Project	IEEE 802.16 Broadband Wireless Access Working Group < http://ieee802.org/16 >
Title	Amendment to Location Update Primitives in 14.2.4.3
Date Submitted	2007-03-1408
Source(s)	JeeHyeon Na, Jaesun Cha, Jung-Mo Moon and Sangho Lee jhna@etri.re.kr ETRI 161 Gajeong-dong, Yuseong-gu Daejeon 305-700 Korea
Re:	Contribution on comments to IEEE 802.16g/D8
Abstract	Re-definition of location update service primitives in section 14.2.4.3
Purpose	Adoption
Notice	This document has been prepared to assist IEEE 802.16. It is offered as a basis for discussion and is not binding on the contributing individual(s) or organization(s). The material in this document is subject to change in form and content after further study. The contributor(s) reserve(s) the right to add, amend or withdraw material contained herein.
Release	The contributor grants a free, irrevocable license to the IEEE to incorporate text contained in this contribution, and any modifications thereof, in the creation of an IEEE Standards publication; to copyright in the IEEE's name any IEEE Standards publication even though it may include portions of this contribution; and at the IEEE's sole discretion to permit others to reproduc

Figure 484 – Location Update Primitives

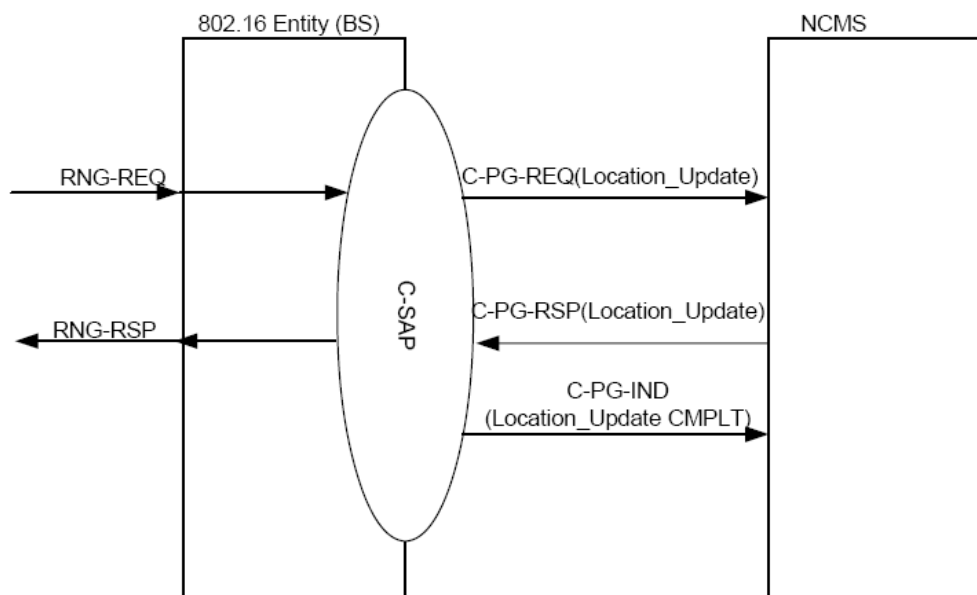
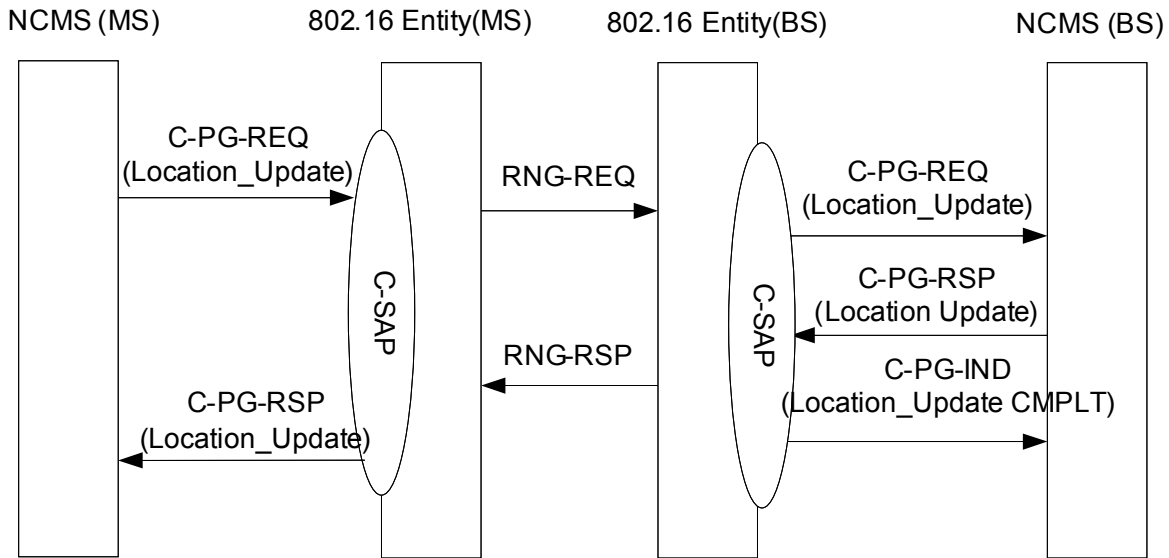
Therefore, we modify the figure 484 and some related texts to be included service primitives between an 802.16 entity (MS) and an NCMS on MS side in this contribution.

Figure 484 shows service primitives for Location Update between ~~an 802.16 entity~~ a BS and the NCMS.

All the above Location Updates are realized by Ranging request/response (RNG-REQ/RSP) message between an MS and a BS, and the C-PG-REQ, C-PG-RSP, C-PG-IND service primitives are defined between ~~a BS~~ an 802.16 entity and the NCMS to perform Location Update.
